DES MOINES RECREATIONAL RIVER AND GREENBELT

FEATURE DESIGN MEMORANDUM #8 WITH ENVIRONMENTAL ASSESSMENT

DOWNTOWN RIVERFRONT
PLAZA/AMPHITHEATER

SUBJECT: Response to NCD's Comments to Draft FDM No. 8,
Downtown Riverfront Plaza/Amphitheater, Des Moines
Recreational River and Greenbelt, Iowa

Retaining Wall

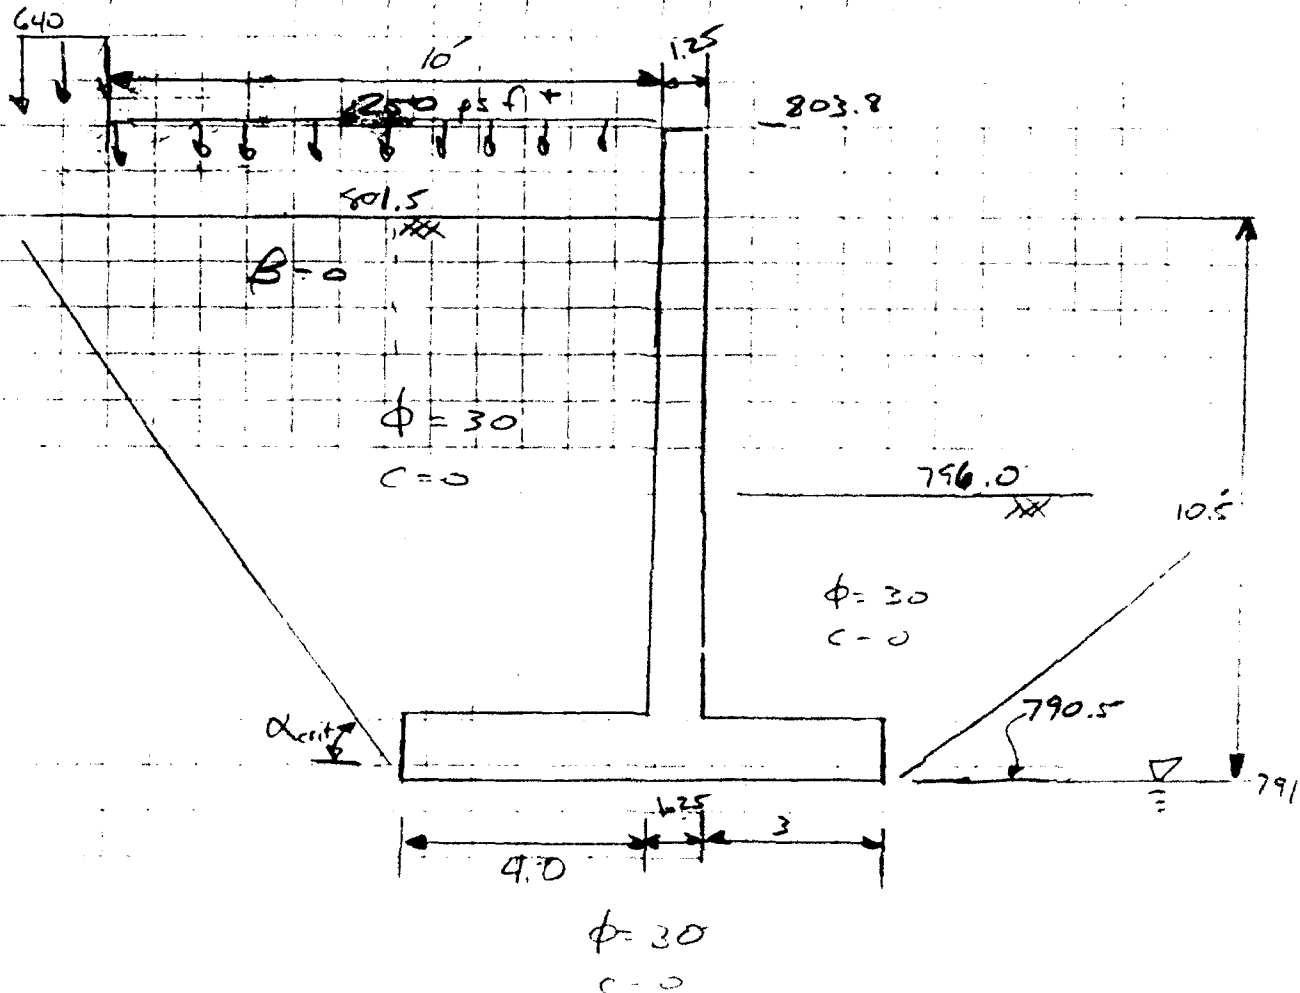
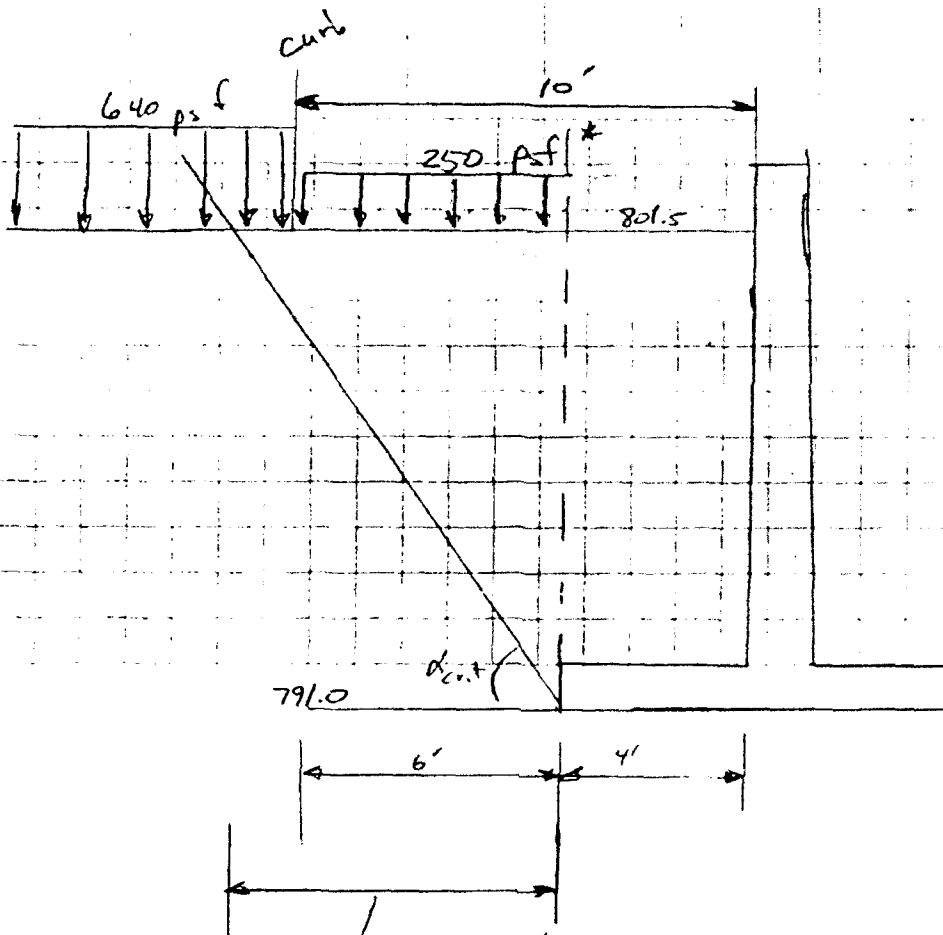
14. COMMENT: Plate D-65, D-68 and D-103. The $\phi = 25$ deg. is very conservative. A minimum of 30 deg. and possibly 32 deg. is recommended for footing design. Redo to see if a more economical retaining wall section results.

14. RESPONSE: Plates D-65 and D-68 - Overturning is governing the design of the retaining wall and therefore increasing Φ from 25 to 30 deg. for the foundation material will not change the overturning stability of the wall. However, the analysis has been revised and the ϕ angle has been changed to 30 degrees.

Use $\phi = 27^\circ$ for all soil
SMF = $\frac{2}{3}$

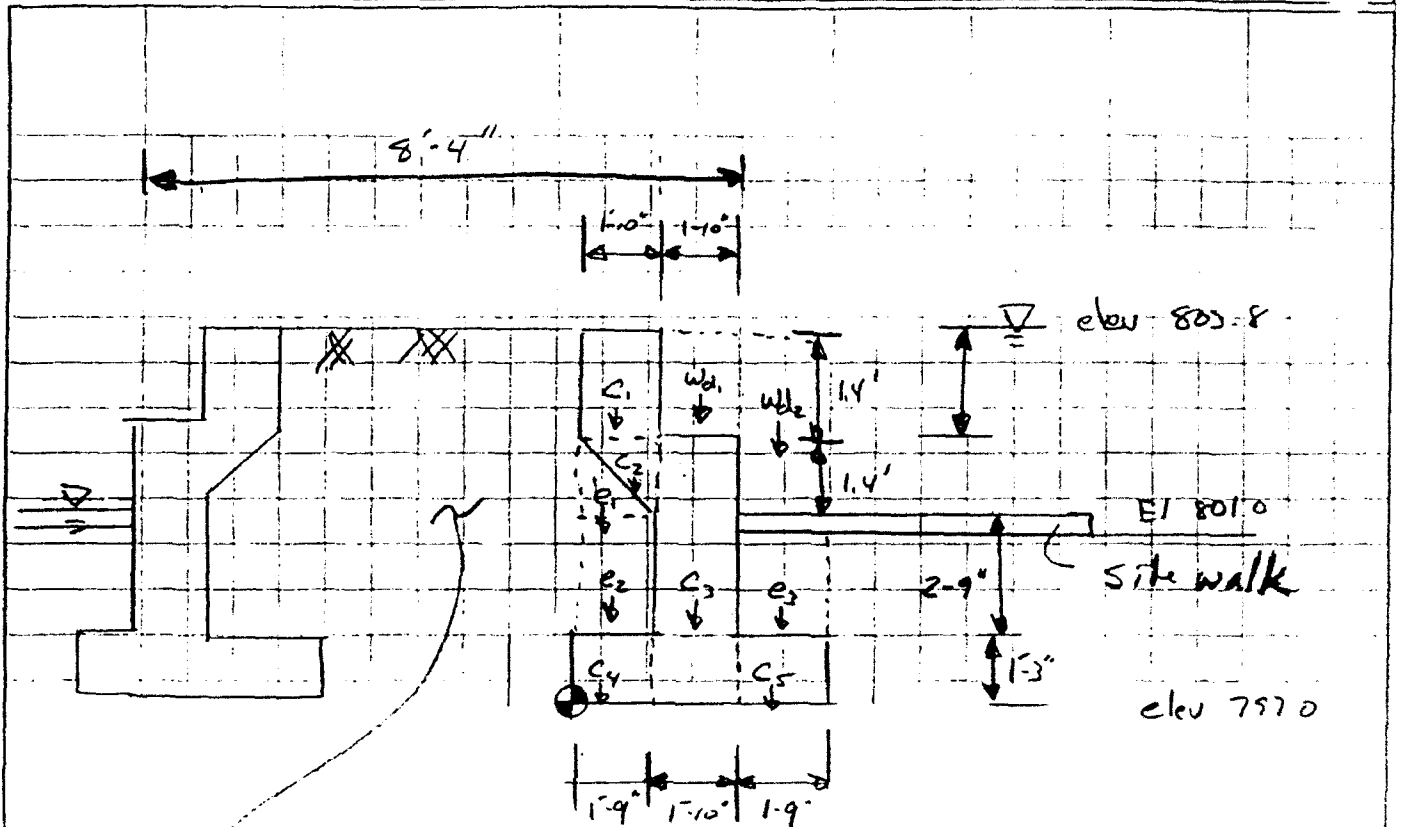
15. COMMENT: Plate D-74. The $\phi = 27$ deg. is too conservative. Redo using $\phi = 30$ deg. or 32 deg.

15. RESPONSE: Since the foundation capacity is not governing the size of the retaining wall base, the use of $\phi = 30$ in lieu of $\phi = 27$ will not result in a less costly structure. However, the analysis has been revised using $\phi = 30$ degrees.

ARCH PLAN VIEW

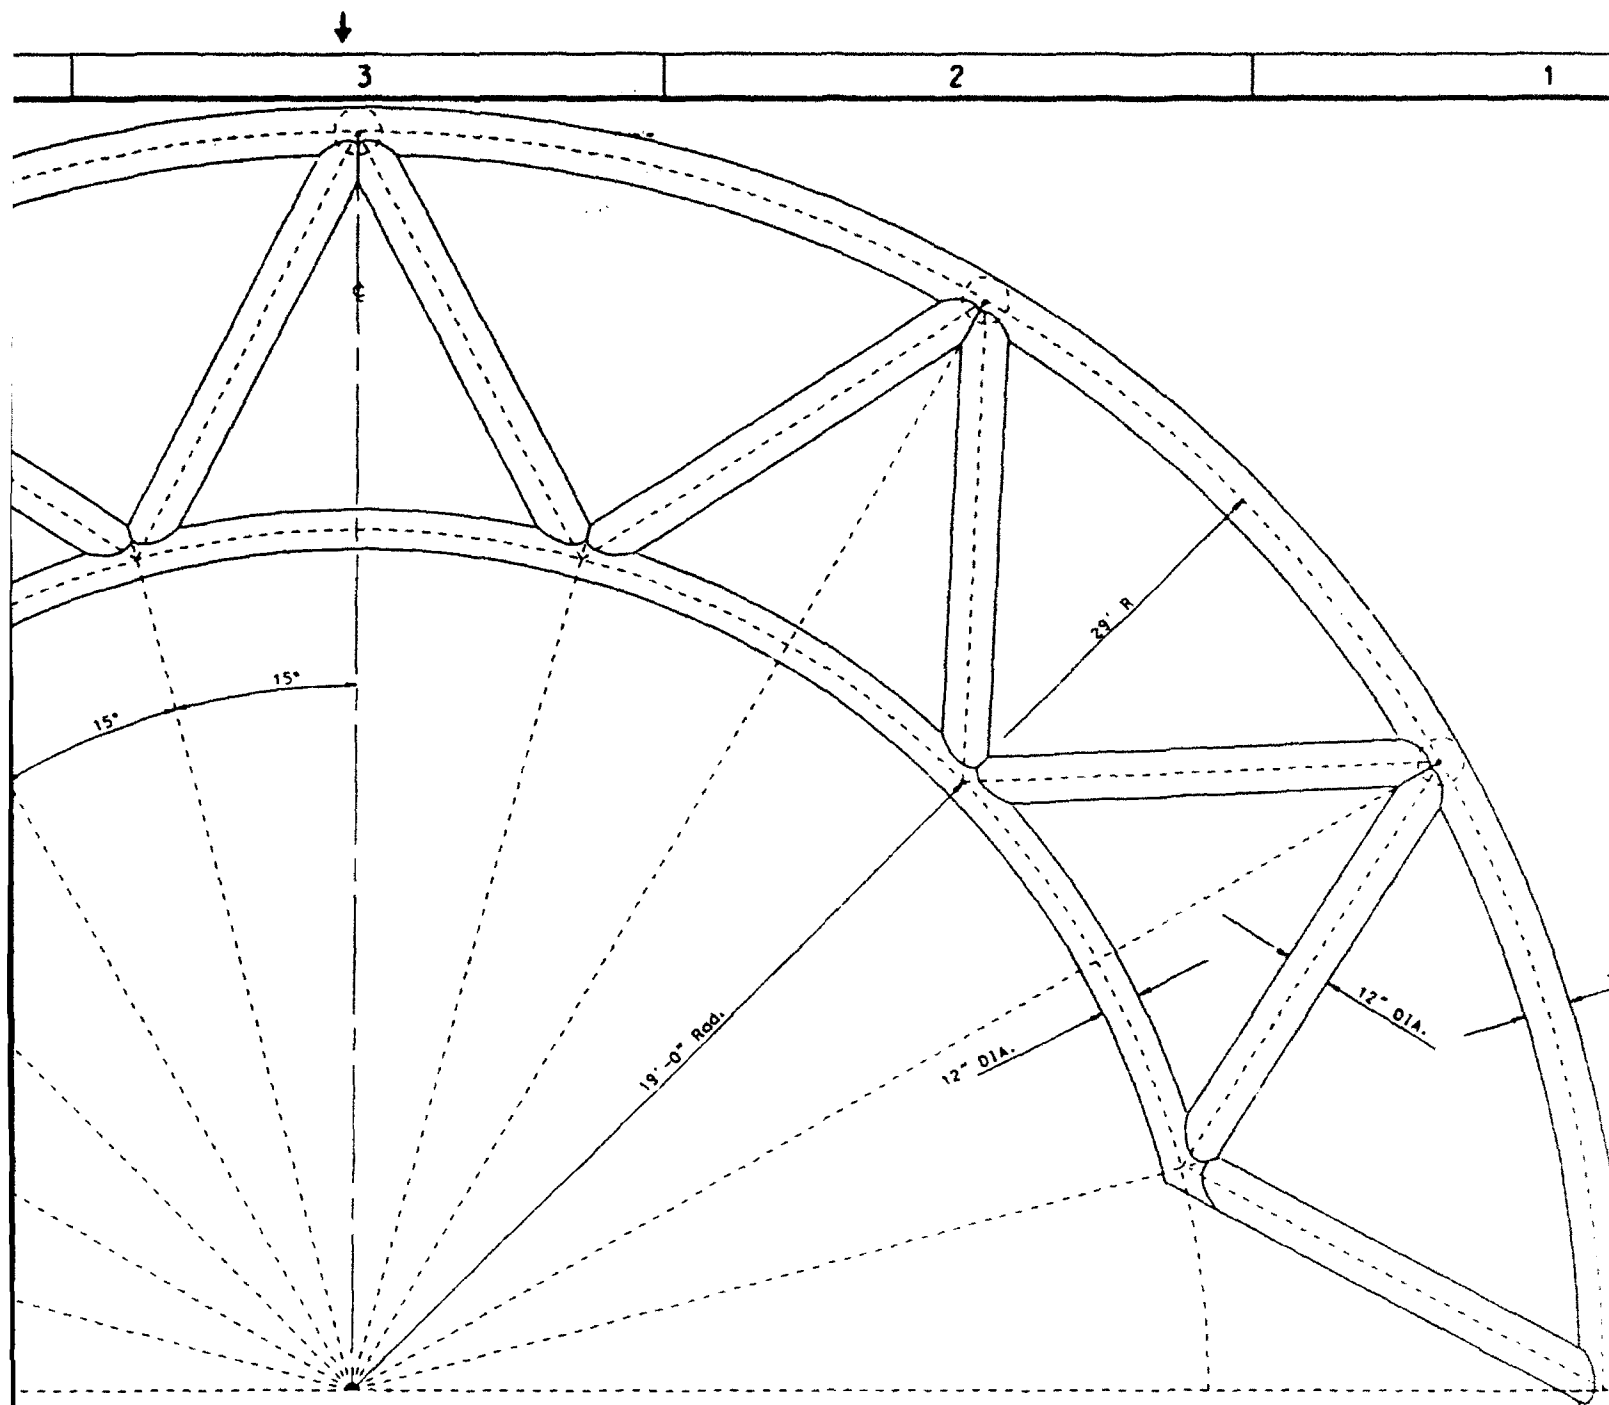
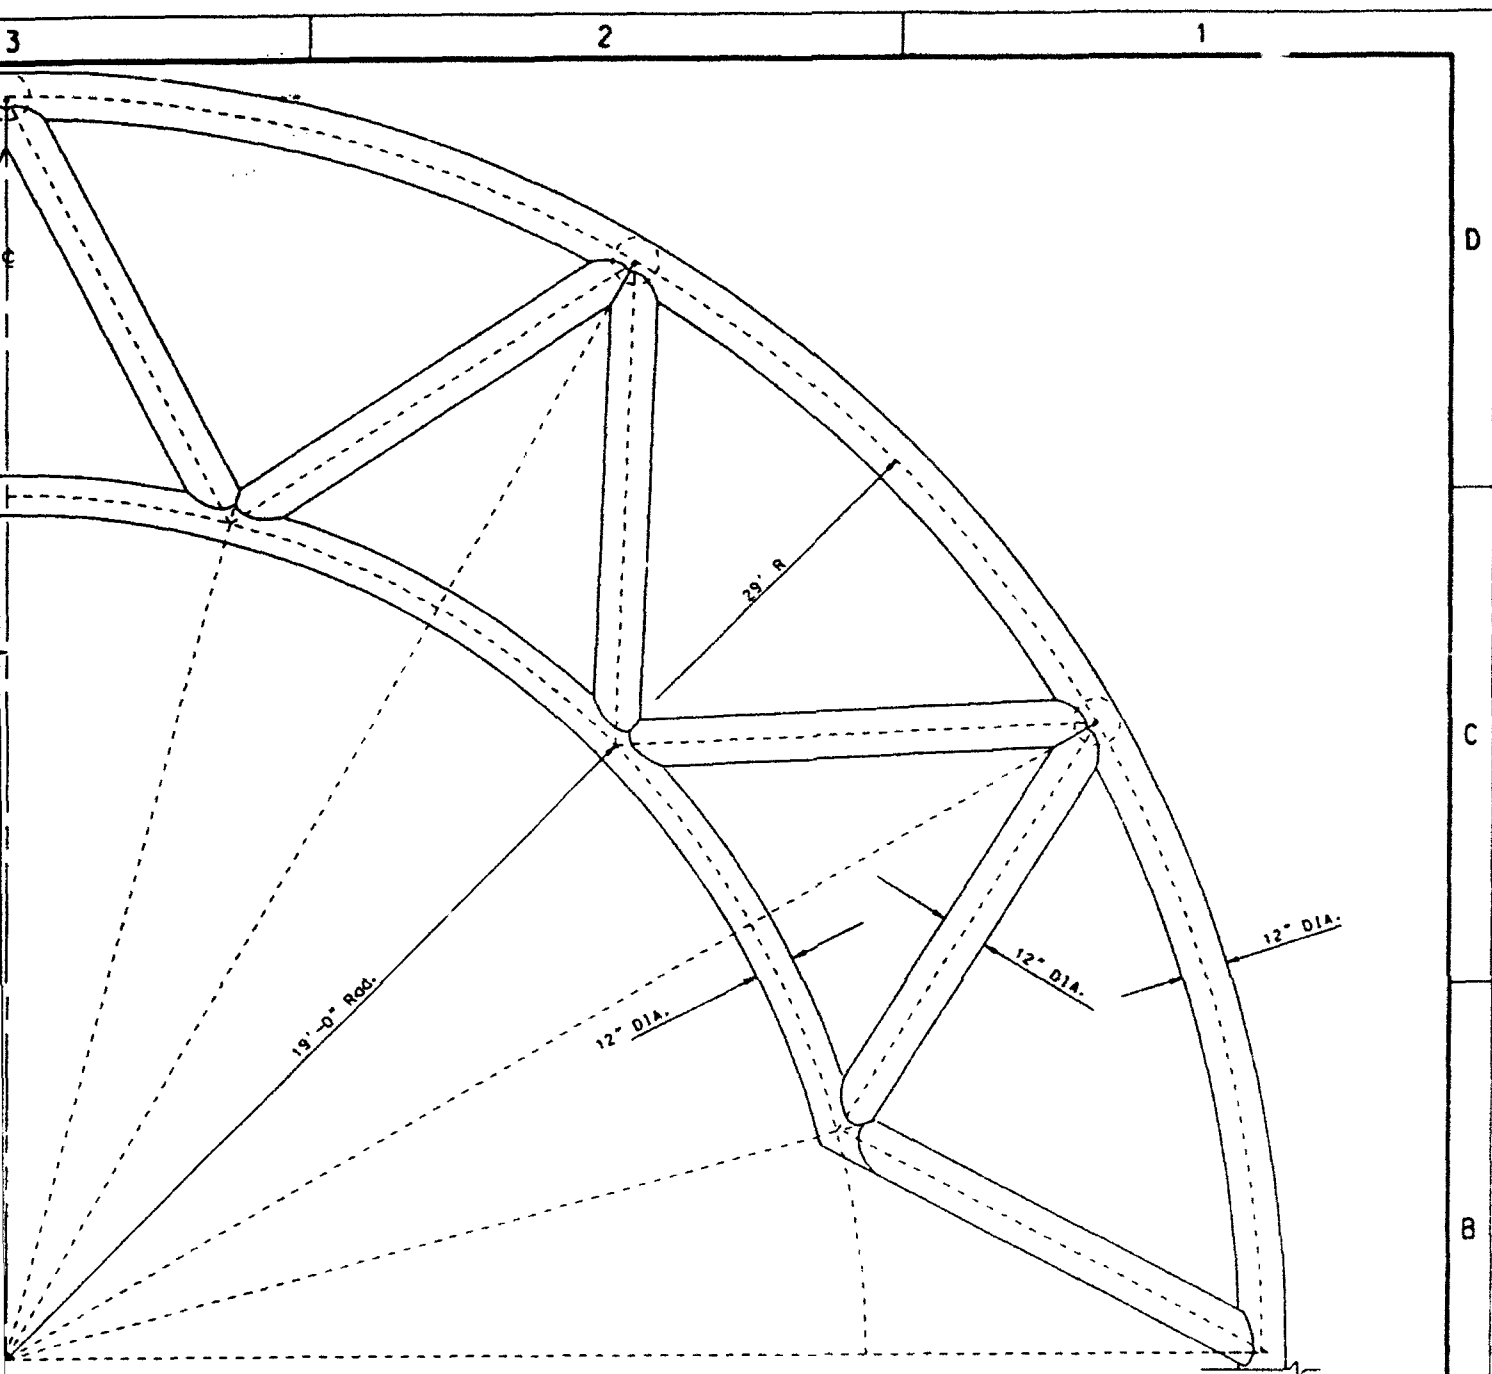
2. COMMENT: Appendix D. Structural calculations have not been checked. The input for the GT STRUDL lists dimensions to the outside of the 12" diameter pipe. Verify that the centerline need not be used. Sheet S-5, Arch Plan View, shows center to center dimension of 56'-11.25". It should be 57', because the outside dimension of the pipe is equal to 12". Explain the function of HP 14*73 indicated on the Support Detail.

2. RESPONSE: Appendix D has been completely revised. All structural calculations have been checked. The arch was modelled correctly; however, the center of the arch should be dimensioned rather than the outside as shown on the drawings. The HP14x73 has been deleted from the support detail. Plates 13, 14, and 15 were modified to reflect these changes.
